# CITY OF OAKLAND

### Planning Commission Design Review Committee

Subject: Proposal at 2201 Valley Street – Continued from August 8, 2018 Design Review Committee Meeting;

# 2201 Valley

THE CROWN

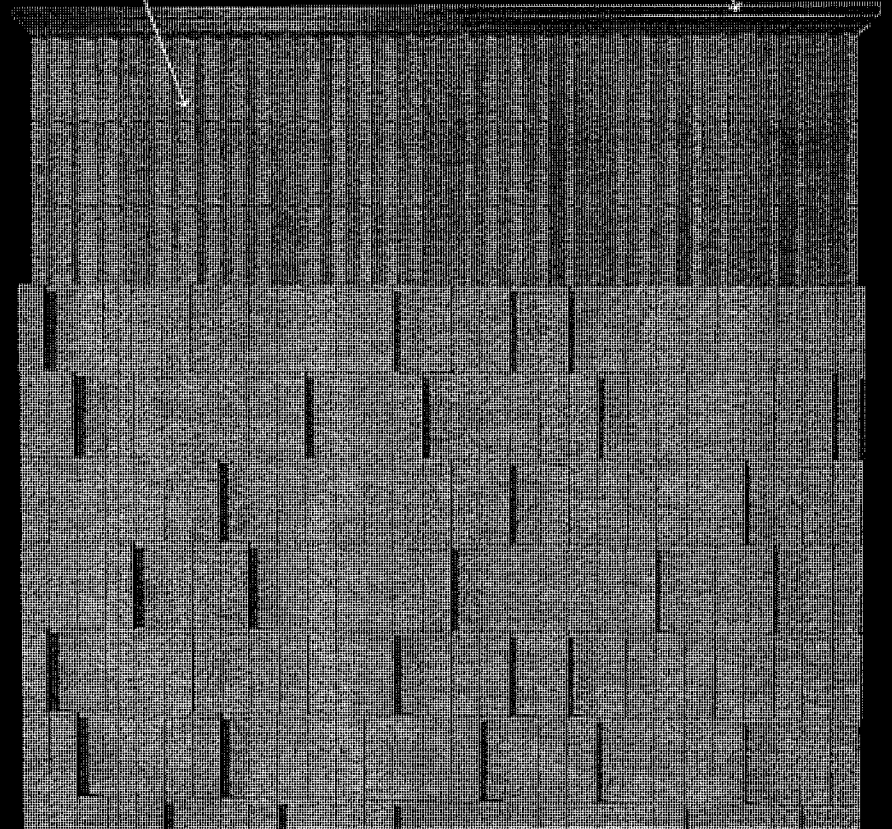
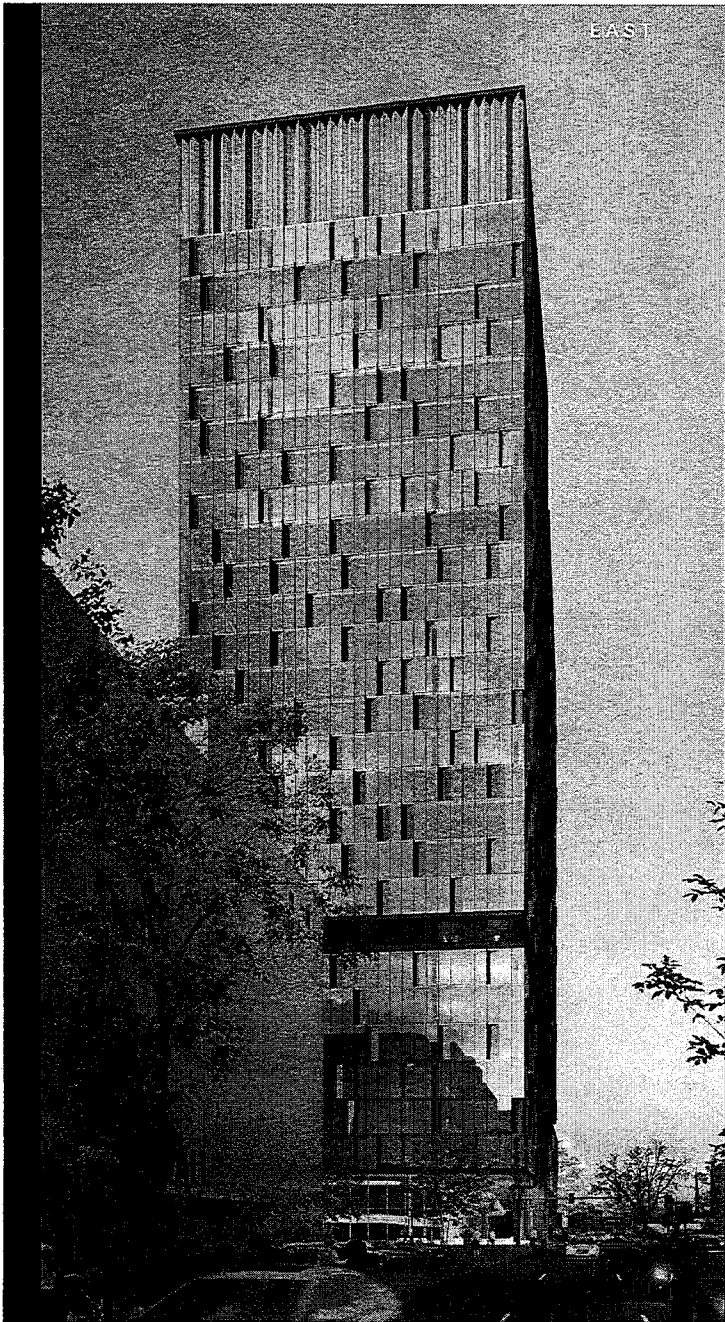
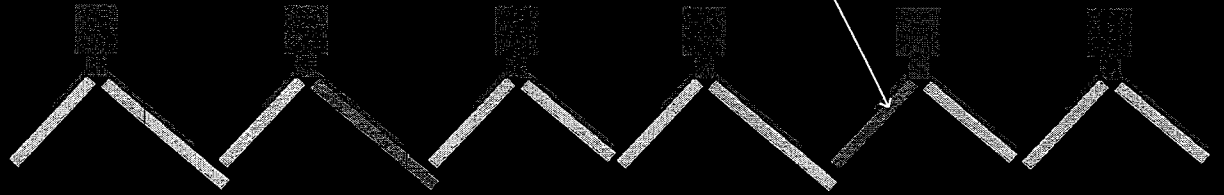
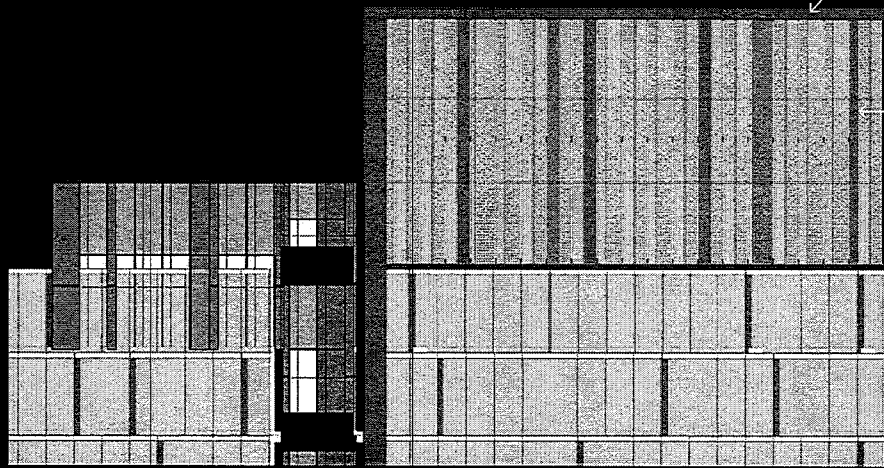
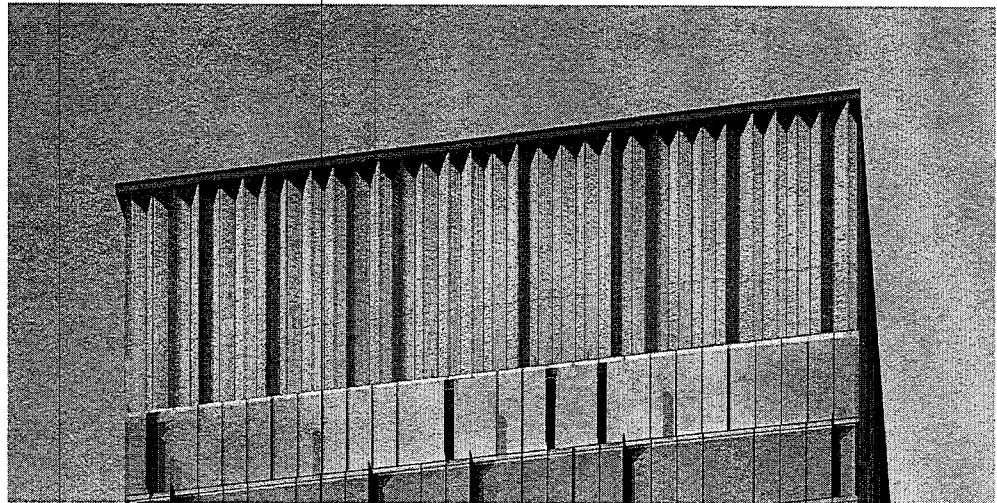
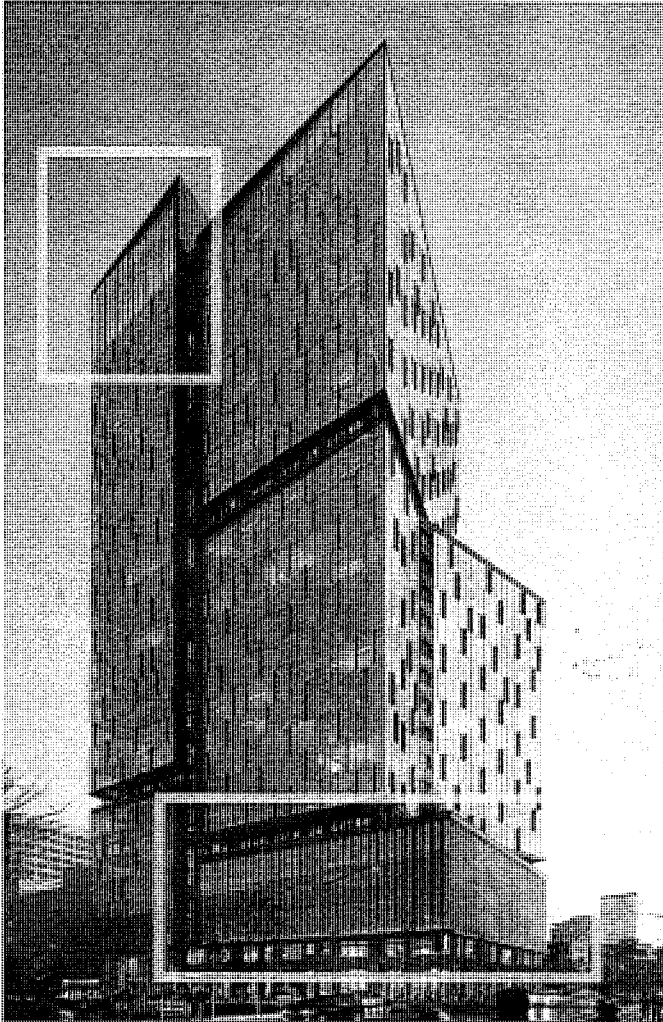
The building tower terminus as seen from the west was raised as a design concern at the prior DRC meeting. The concern was that the view from the west didn't include a clear distinction of the tower top from the rest of the tower façade. The applicant has provided updated design concepts and more detailed information for consideration by the Committee.

PERFORATED METAL ALUMINUM  
SCREEN IN ANGLED PANELS WITH  
INTEGRATED COSTEN PANELS

METAL COSTEN TRIM  
FRAMING TOP AND SIDES  
OF THE CROWN
